Access Compliance Report

Public Rights-of-Way

(Pedestrian Signals)

Intersection ID: N/A	Main Street:	Cross Street: N/A	Location: N/A
ADA ID: A21E71C70A64	Signal Type: Two Push Buttons-Non APS	Overall Compliance: No	Severity Score: BTN 1:N/A BTN 2: N/A No BTN: N/A
Codes/Mitigation Info/Possible Solution		Field Measurements/Component Compliance

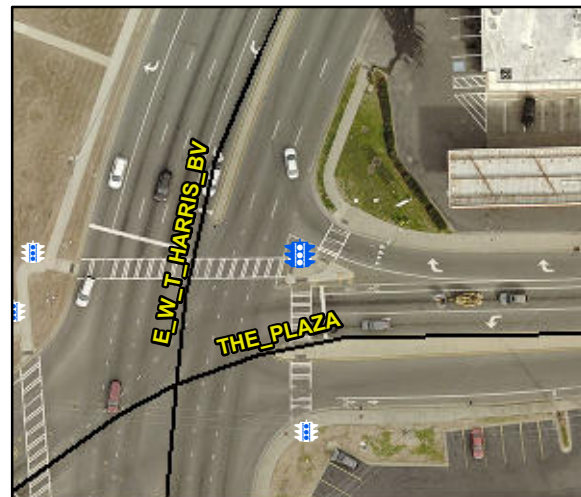
Surveyor Notes: TEXT HT 1/2

PROW/ADA: R410.6, R404.2, R404.3, R406.2, R404.7.3

Possible Solutions: Remove & Replace Sign. Provide Push Button Extension. Remove and Replace Clear Space.
